SB TMG 125-1020 P1, Revision 1

# SERVICE BULLETIN

**Service Bulletin No. / Date:** SB TMG 125-1020 P1, Revision  
January 5, 2018

**Subject:** Gearbox Oil Leak Inspection

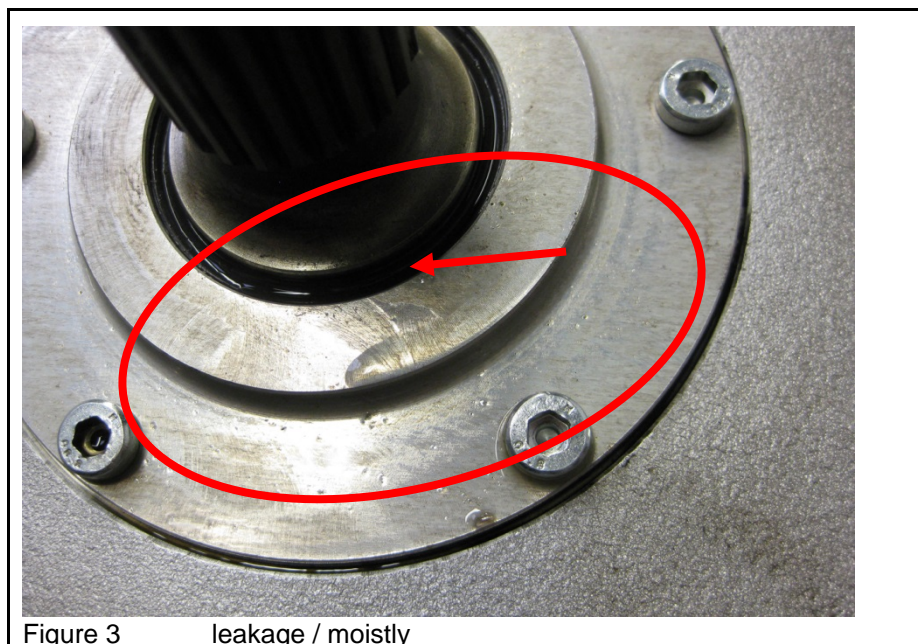
- Remove the gearbox and replace the clutch by dual mass flywheel in accordance with RM-02-02, Chapter 72-10.18, Issue 3, Revision - or later approved revisions.
- Inspect the gearbox, check the rear radial shaft sealing ring on the gear shaft for oil leakage and moisture, see Figure 2 and Figure 3.

- If there is a leakage or moisture, see Figure 3, replace the gearbox.
